## Washington Public Power Supply System

Subject: SUPPLY SYSTEM NUCLEAR PROJECT NO. 3  
ENVIRONMENTAL REPORT - OPERATING LICENSE STAGE  
RESPONSE TO NRC REQUEST FOR INFORMATION

RESPONSES TO NRC QUESTIONS OF APRIL 6, 1983 (Re: WNP-3 ER-OL)

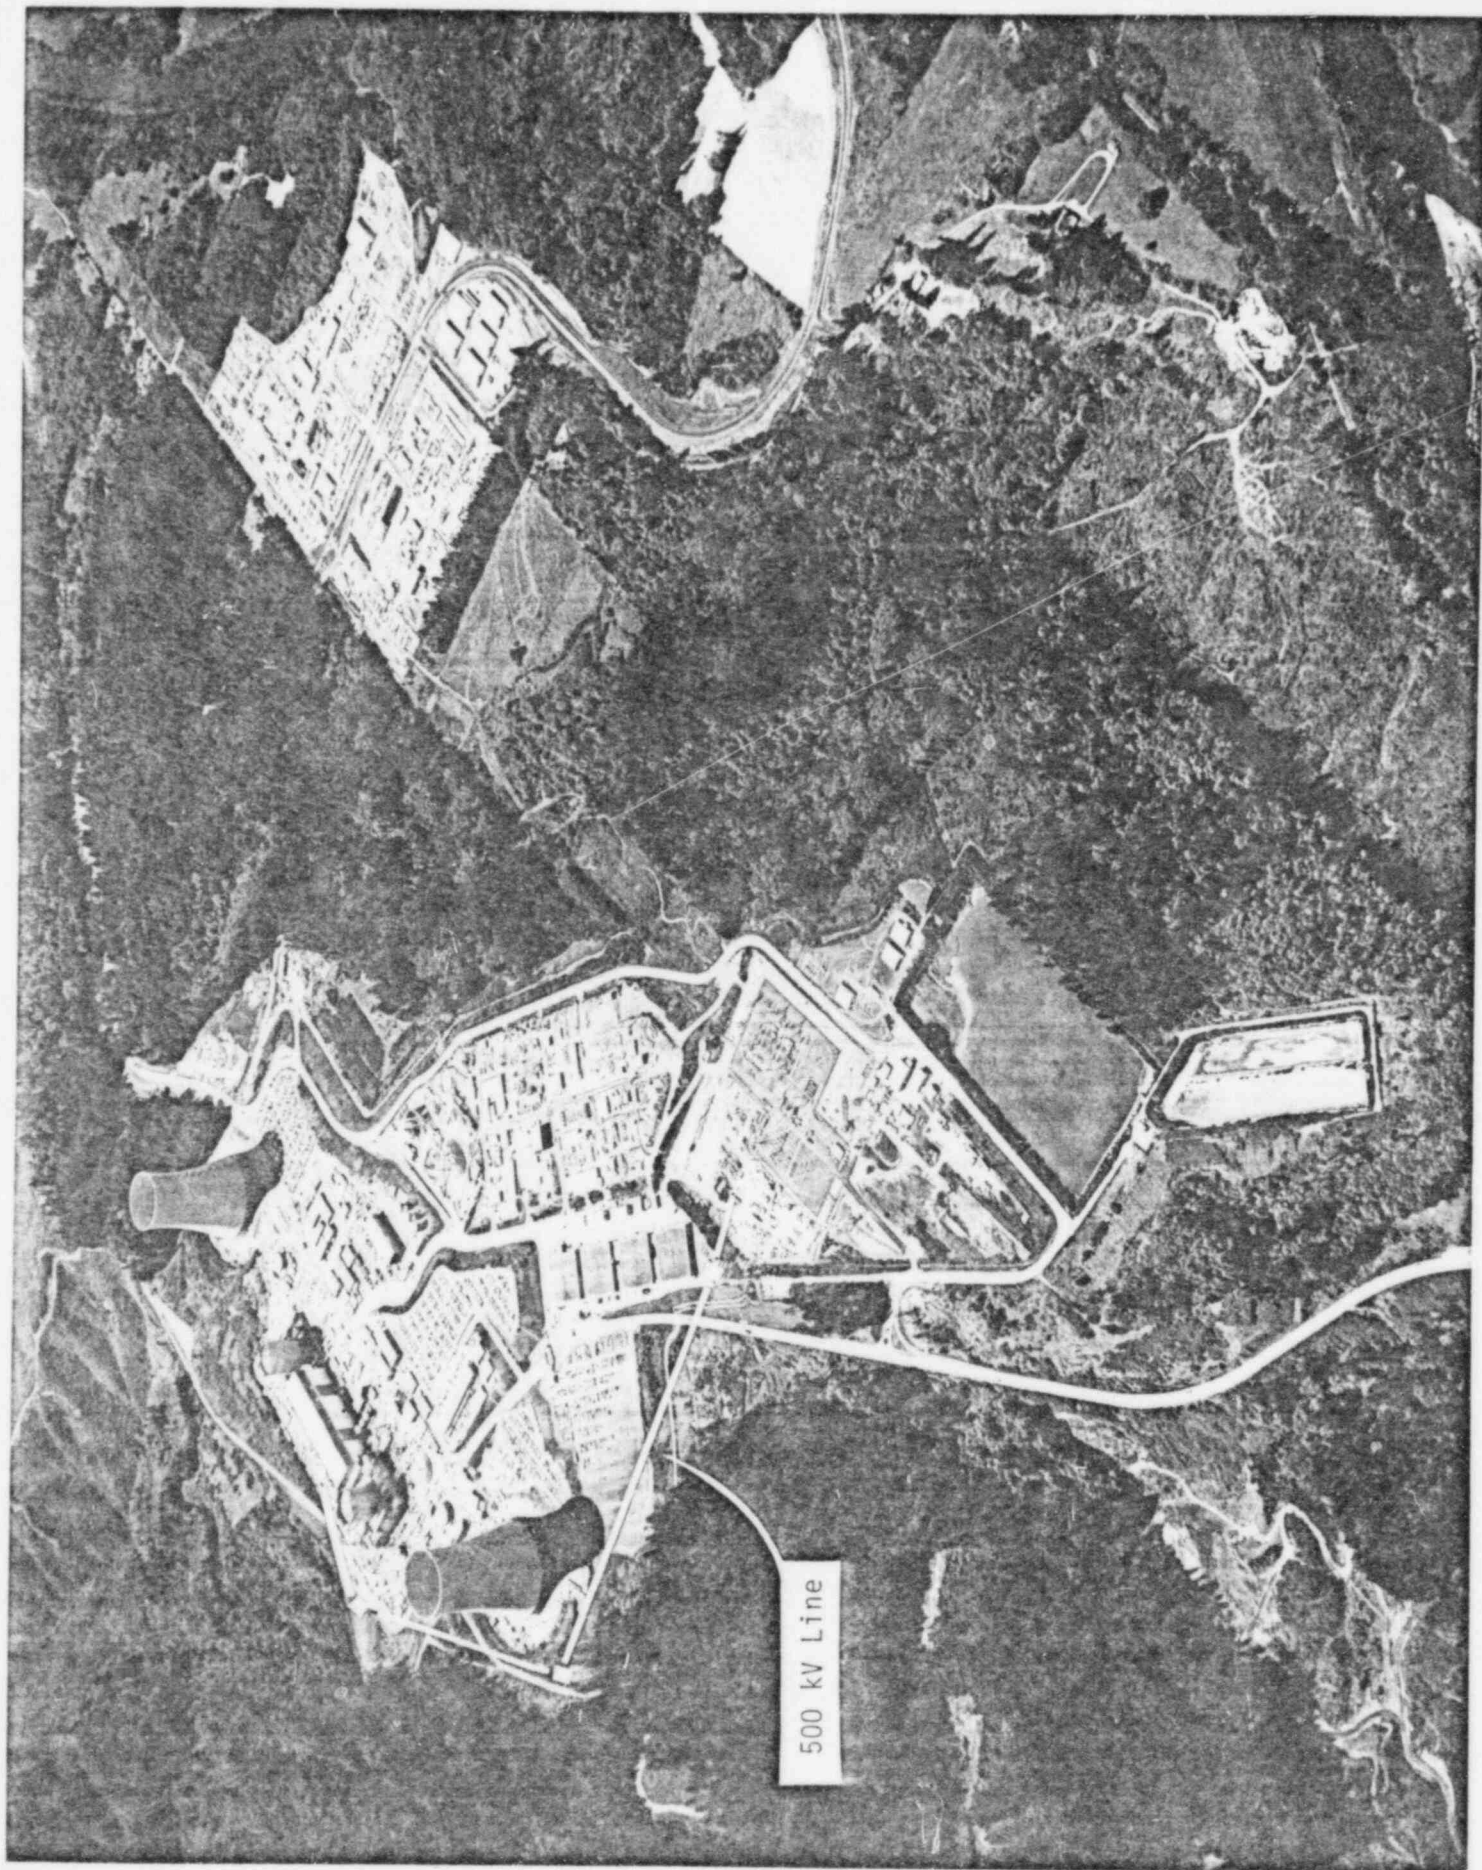
290.12 Q. Identify the final routing alignment between WNP-3 and the BPA's Satsop Substation for the 500-kV line. Show locations of towers and vegetative cover types along the proposed routes.

A. The routing of the WNP-3 to Satsop Substation 500-kV line (including tower locations) is shown in the attached figure. The route is also indicated on the attached copy of an aerial photograph. The entire route is over areas previously cleared for plant construction. The reestablished vegetative cover includes red alder, Douglas fir seedlings, and grasses. The figure will be incorporated into Section 3.9 of the ER-OL by amendment.
